320170010, WESTWOOD SHOPPING CENTER SKETCH PLAN

DRC COMMENTS SUMMARY (as of 8-19-16)

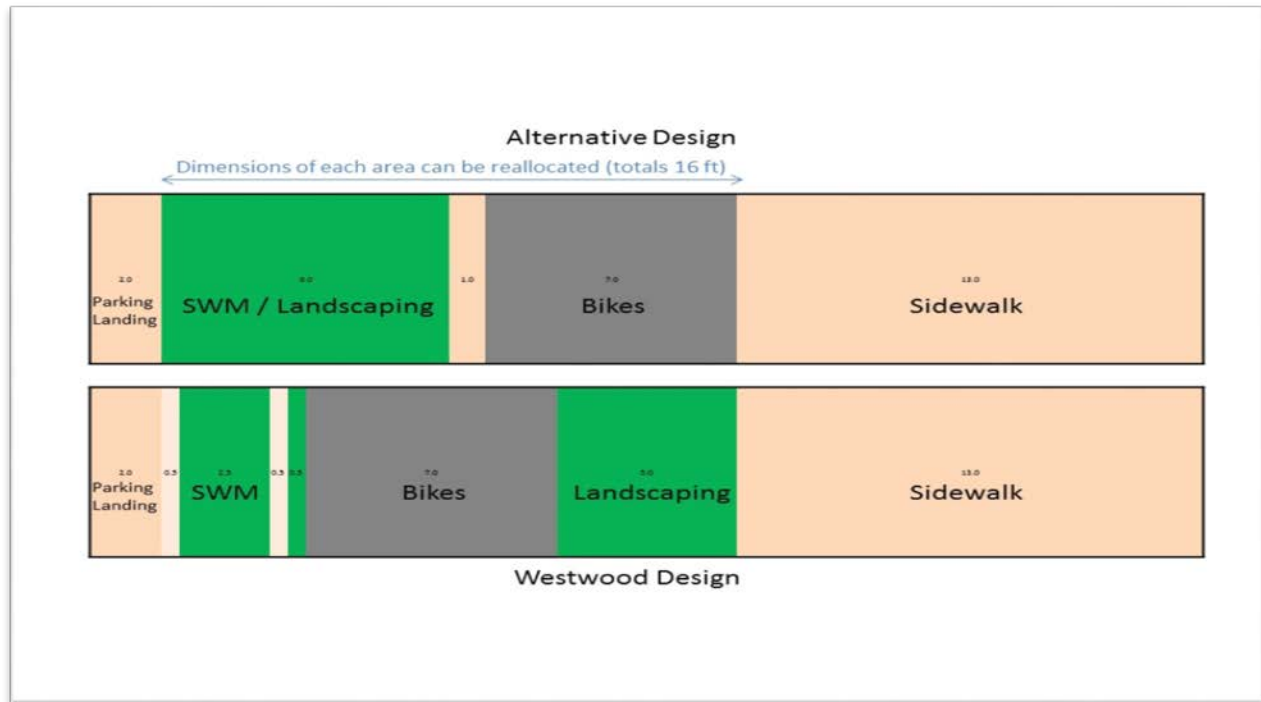
- a. Locations of the proposed traffic signals. Signal warrant studies, based on projected traffic volumes and turning movements, will need to be reviewed and conceptually approved by our Division of Traffic Engineering & Operations. As noted in the attached drawing below, we recommend these studies consider installing signals on realigned Westbard Avenue with relocated Ridgefield Road and proposed private street C.

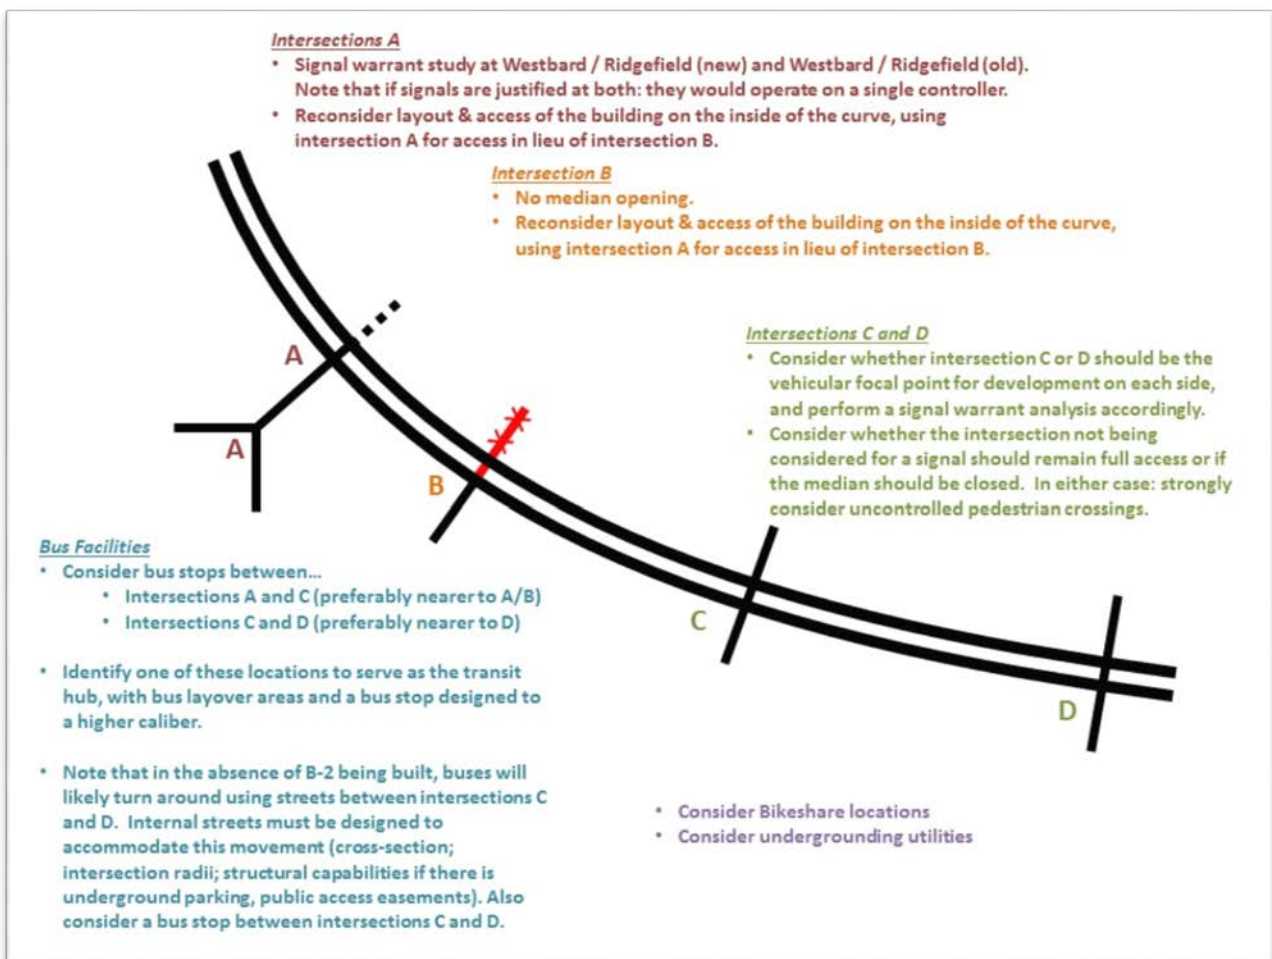
2. At the preliminary plan stage, provide a typical section in accordance with the latest master plan.
- a. Consider modifying the section (p. 30 of the **Westbard Sector Plan**) to combine the two green space sections into one 8' SWM/landscaping section, with a 2' parking landing on one side and a 1' separation between the cycle track. All other dimensions would remain the same. (See the "Alternative Design" cross-section sketch below)
